REvised PAPERSON SHOWING

PROPOSED USE OF EXISTING WASH BAY AS STORES AND DOUBLE DECK REST ROOM.

DEVELOP 4/10/1976

1st Floor Plan.

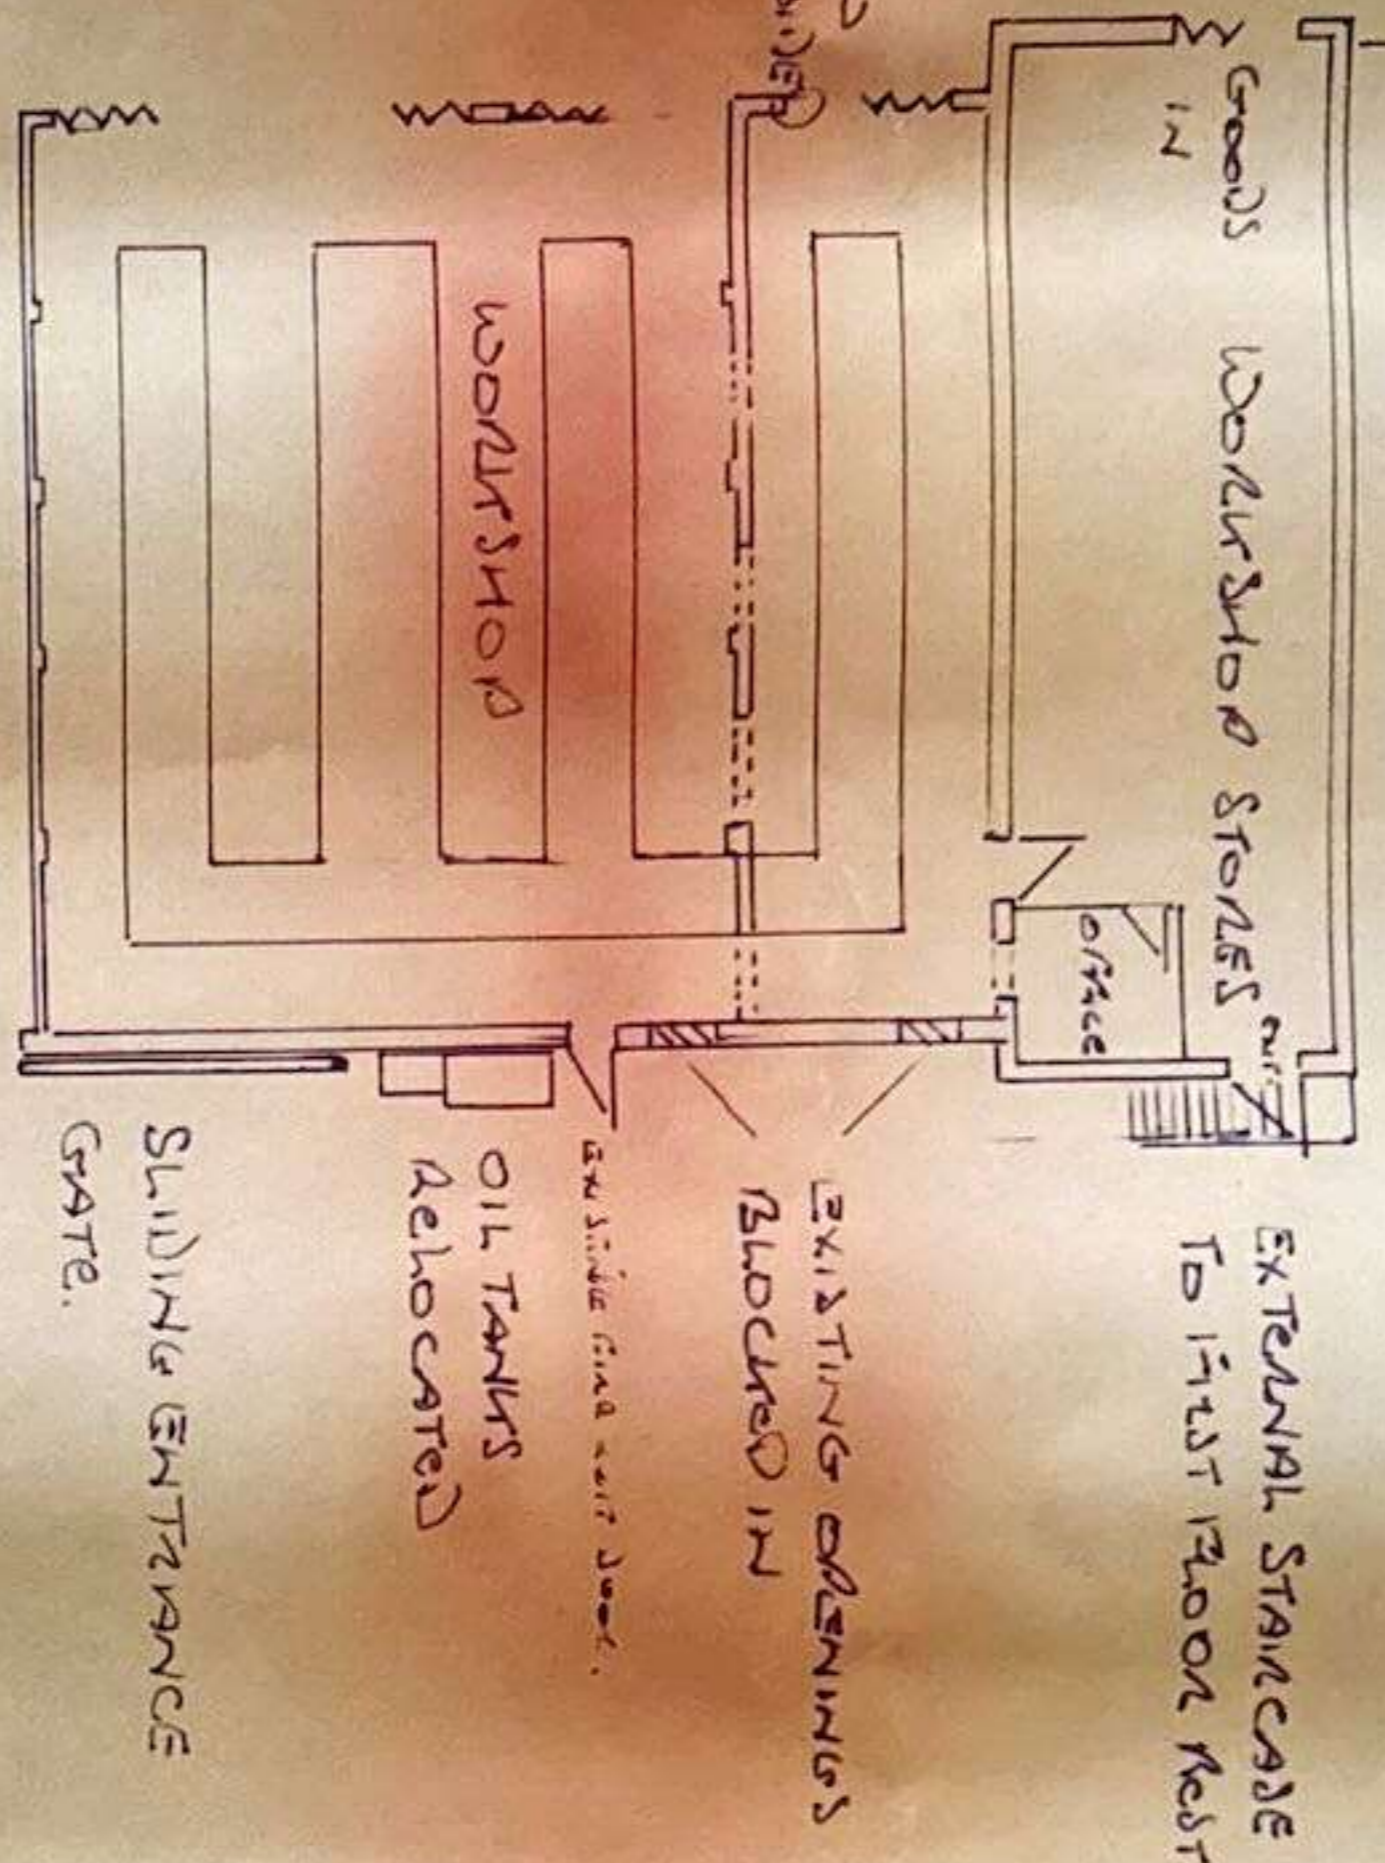
REPAIRMENTS TO BE PROVIDED TO 1ST FLOOR.
 HEATING REQUIRED TO OFFICE AND STAFF REST AREA.
 GOODS IN "ENTRY TO ALKOIDS ACCESS UNIT FOR LIFT TRUCK."
 DOORS TO STORES CLOSED IN AND LIFT TO WATER EXISTING.

GROUND FLOOR PLAN.

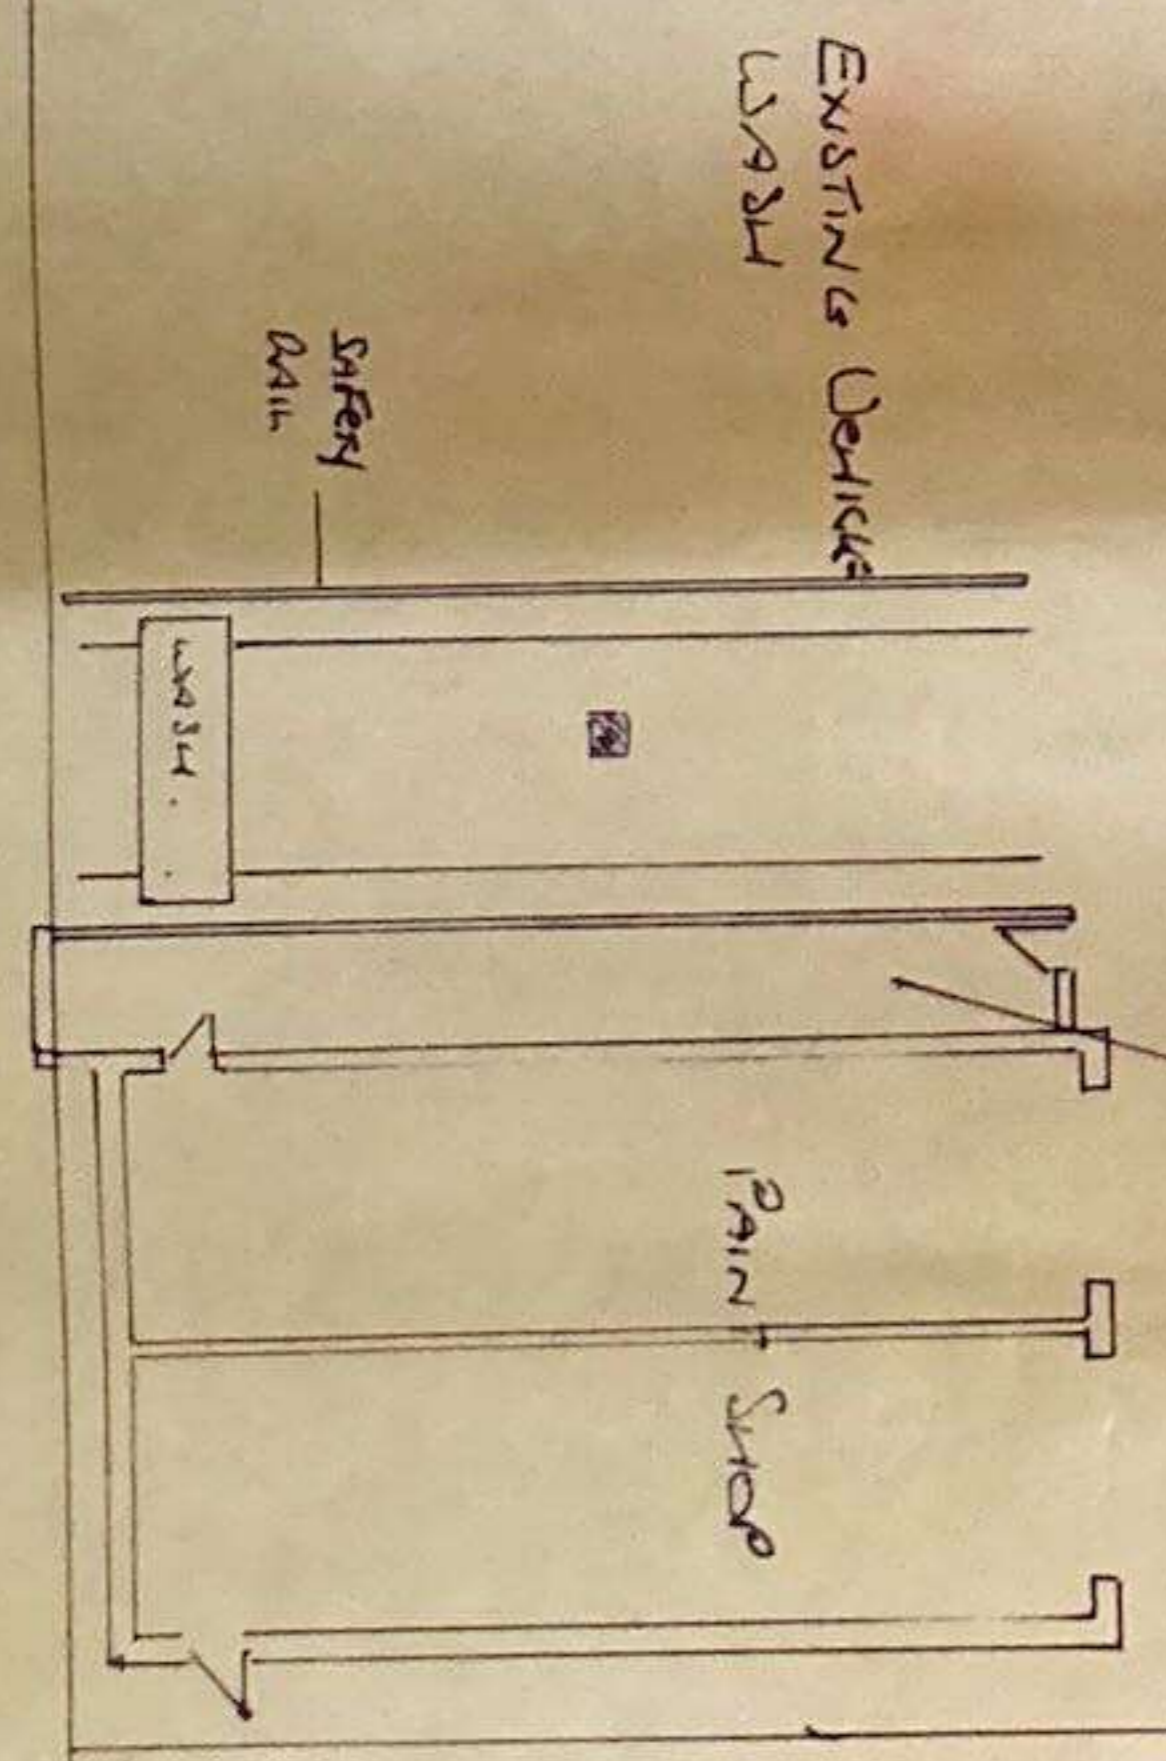
ADDITIONAL 1500mm AND DOWN HEIGHT INCREASED TO ACCOMMODATE DOUBLE DECK (INDICATED).
